Pre-Submittal Presentation – Adoption of TSTF-266-A, Revision 3, Eliminate the Remote Shutdown System Table of Instrumentation and Controls, LAR

April 2023

Proposed TS Changes to 3.3.11

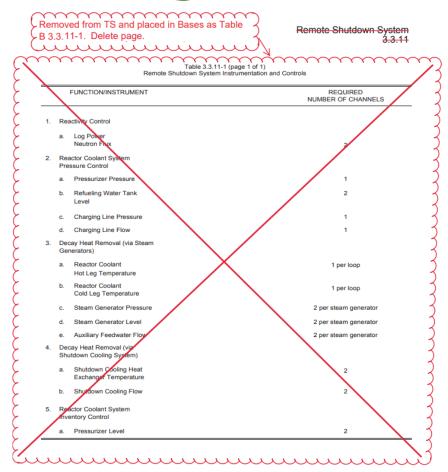
LCO 3.3.11 The Remote Shutdown System Instrumentation Functions in Table 3.3.11 -1 and each Remote Shutdown System disconnect switch and control circuit shall be OPERABLE.

CONDITION		REQUIRED ACTION		COMPLETION TIME
Α.	One or more required Functions -in Table 3.3.11.1 inoperable.	A.1	Restore required Functions to OPERABLE status.	30 days
